TITLE
GROUND FLOOR PLAN

RD CONTENT
PREMIER PARK,
PARK ROYAL, N10 7NZ

SCALE AT A1: 1:50	SCALE AT A3: 1:100	DRAWN AD	ISSUED AD
JUNE 2021	JOB NO. 770	DRAWING A1-100	REV X

1 GROUND FLOOR PLAN

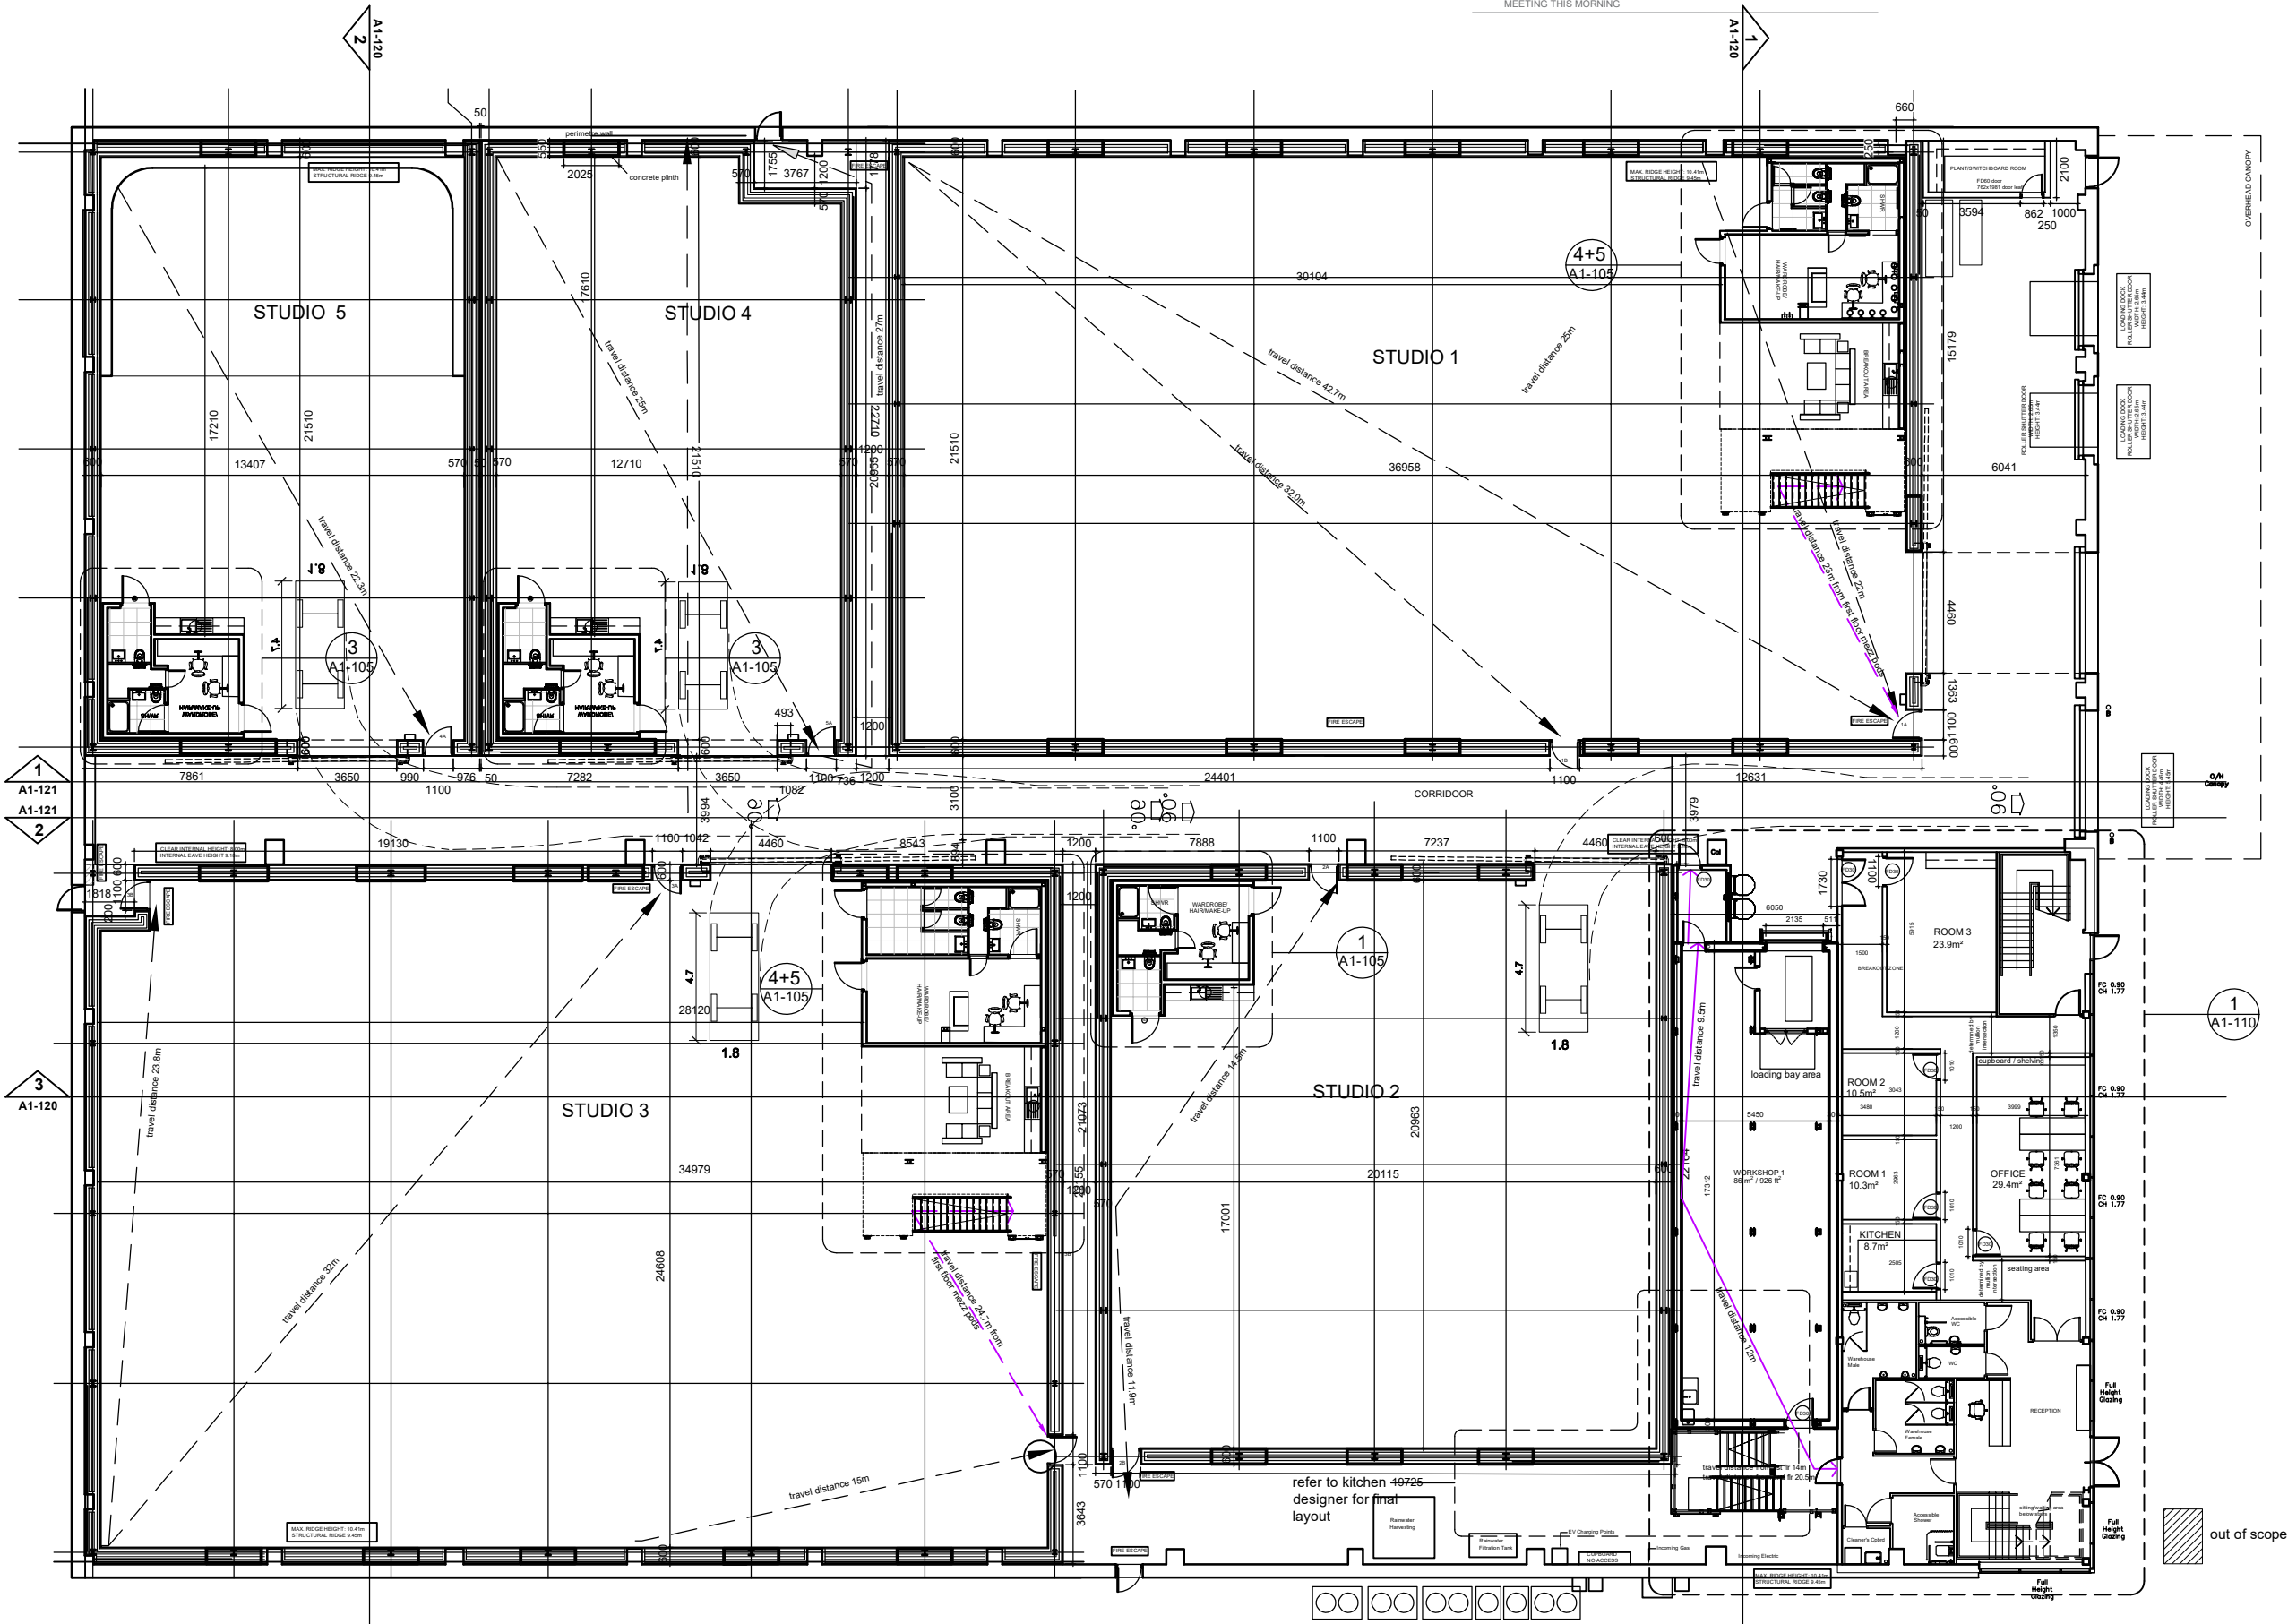
-	GROUND FLOOR PLAN SHOWING GENERAL ARRANGEMENT WITH MODIFIED MEZZANINE PODS	22.06.2021	-	JS
A	GROUND + FIRST FLOOR G/PLANS MODIFIED FROM MEETING THIS MORNING	24.06.2021	-	JS

B	GROUND + FIRST FLOOR PLANS MODIFIED TO INCORPORATE DOGLEG STAIRS TO MEZZANINE PODS	28.06.2021	-	JS
C	STUDIO 5 ADJUSTED TO MAKE BETTER US OF FIRE ESCAPE DOOR TO BASE BASE	02.07.2021	-	JS
D	GENERAL MODIFICATIONS THROUGHOUT FOLLOWING MEETING ON 5.07.21: STUDIO WALLS REDUCED TO 650mm THICK, STUDIOS 4 + 5 OMITTED STAIRS, GENERAL FIRE ROUTES UPDATED, STUDIO 5 INCLUDES AN ACCESS CORRIDOR, VIP ACCESS ROUTE INCLUDED, KITCHEN MODIFIED TO PERMIT ACCESS TO STATUTORY EQUIPMENT	07.07.2021	-	JS

REV	NOTES	DATE	BY	AUTH
E	STUDIO 1 REDUCED TO ENABLE A CORRIDOR TO NEIGHBOURING STUDIO 5, MEZZANINE PODS RELOCATED TO FRONT CORNER OF STUDIO 3, CENTRAL RUNWAY CORRIDOR HAS A 6m FLR TO CEILING HEIGHT & VIP ACCESS MODIFIED, STATUTORY EQUIPMENT TO BE REVIEWED WITH OWNER IN ACCORDANCE WITH RD Content ACCESS REQUIREMENTS	07.07.2021	-	JS
F	BARISTA COFFEE TABLE AND COUNTERTOP ADDED INTO DINING FACILITY	08.07.2021	-	JS
G	SECTION LINES ADDED	14.07.2021	-	JS
H	-STUDIO WALLS REDUCED TO 600mm -ADDITIONAL SECTION LINES ADDED THROUGH THE CORRIDOR -ISOLATION MATERIAL AROUND THE STUDIO PERIMETER INDICATED -VIP ACCESS DOOR SWING INWARDS AND PROTECTION BOLLARDS INSTALLED	20.07.2021	-	JS
J	LAYERS REMOVED ABOVE BASE PLAN TO SHOW FIRE EXIT ACCESS	21.07.2021	-	JS
K	FOLLOWING SITE MEETING ON THE 03.08.2021 CHANGES TO: -STUDIO WALL ARRANGEMENTS -ADDITIONAL STORAGE FACILITY BEHIND STUDIO 2 -NEW GROUND FLOOR FRONT-OF-HOUSE LAYOUTS -NEW FIRST FLOOR FRONT-OF-HOUSE LAYOUTS -RAISED CEILING HEIGHTS TO BOTH LEVELS -RELOCATION OF ESCAPE DOOR AND ADDITIONAL SHUTTER AT FRONT	05.08.2021	-	JS

L	CHANGES FROM EMAIL ON 11.08.21: - STUDIO 1: CHAMFER SQUARED OFF AND RECESSED FOR LARGER DELIVERY AREA. SHUTTER DOORS RELOCATED IN LINE WITH THE MAIN SHUTTER DOORS AND PERSONNEL DOOR RELOCATED. - STUDIO 2: MEZZANINE POD REPLACED WITH MEZ. PODS IN STUDIO 4 + 5. - STUDIO 3: SHUTTER DOOR RELOCATED IN LINE WITH STUDIO 5 SHUTTER DOOR. - KITCHEN AND REFRIGERATOR MODIFIED TO ADJUST TO NEW AREA CONSTRAINTS. - KIT ROOM REDUCED TO FACILITATE ACCESS TO NEW DOUBLE DOOR TO BREAK-OUT ZONE. - STORAGE BEHIND STUDIO 2 NAME CHANGE TO PLANT / SWITCH ROOM.	12.08.2021	-	JS
M	SHUTTER AND PERSONNEL DOORS ALIGNED WITH PLANS	20.08.2021	-	JS
N	MODIFICATIONS TO: - STUDIO PERIMETER WALLS IN LINE WITH EVOLVE'S STRUCTURAL REQUIREMENTS - MEZZANINE POD CHANGES IN LINE WITH NDY SERVICE REQUIREMENTS - WORKSHOP & STORAGE SHOWN AS PLASTER BOARD WALLS - ACCESS ROUTE BETWEEN KITCHEN & STORAGE EXTENDED TO 1200mm	31.08.2021	-	JS

P	- STUDIO 4 + 5 ADJOINING WALLS MOVED CLOSER WITH 50mm CAVITY - STUDIOS 1, 3, 4 + 5 PERIMETER WALLS MOVED CLOSER TO BASE-BUILD WALLS - ASSOCIATED CONCRETE PLINTHS RELOCATED AND STUDIO 5 HALLWAY FACING PLINTH RELOCATED TO ENABLE SHUTTER AND PERSONNEL DOORS TO BE IN-LINE (SHOWN IN RED) - MEZZ PODS WCs RECONFIGURED IN ALIGNMENT WITH NDY COMMENTS - MEZZ PODS GENERAL MODIFICATIONS	07.09.2021	-	JS
Q	GENERAL UPDATE COORDINATING WITH STRUCTURAL DESIGN AND NDY PENETRATIONS	29.08.2021	-	JS
R	SETTING-OUT DIMENSION ADDED FROM EVOLVE'S GRIDLINE G.1: TO EXISTING BASE-BUILD COLUMN. THIS DIMENSION TO BE READ IN CONJUNCTION WITH EVOLVE'S DRWG: 3366-EVE-ZZ-00-DR-0001-C01 MASTER-GRID LAYOUT	11.10.2021	-	JS
S	GENERAL UPDATE COORDINATING WITH: - STRUCTURAL DESIGN SHOWING NEW SETTING-OUT DIMENSIONS AS PER WYN'S REQUEST ON 19.10.2021 - RELOCATION OF SWITCH ROOM	19.10.2021	-	JS
T	GENERAL UPDATE COORDINATING WITH: - STUDIO 3 NEW EMERGENCY DOOR - STUDIO 4 + 5 NEW DOOR SIZE - STUDIO 1 + 3 NEW MEZZANINE SIZE - OFFICE AREAS HATCHED AS OUT OF SCOPE - 7 X EXTERNAL CHILLER UNITS	10.11.2021	-	JS

U	RDC CHANGES: - EXTENDED LARGE MEZZ PODS WITH STANDARDISED DOOR SIZES - INSERTION OF NEW WORKSHOPS - RELOCATING ESCAPE DOOR IN STUDIO 2	26.01.2022	-	JS
V	REALIGNMENT OF STUDIO 2, 4 + 5 MEZZ PODS	31.01.2022	-	JS
W	REVISED MEZZ POD IN STUDIO 1, REVISED WORKSHOPS IN LINE WITH JSW STRUCTURAL DESIGN AND NEW ADMINISTRATION OFFICE LAYOUTS	18.02.2022	-	JS
X	STUDIOS 4 + 5 NAMES INTERCHANGED	11.04.2022	-	JS
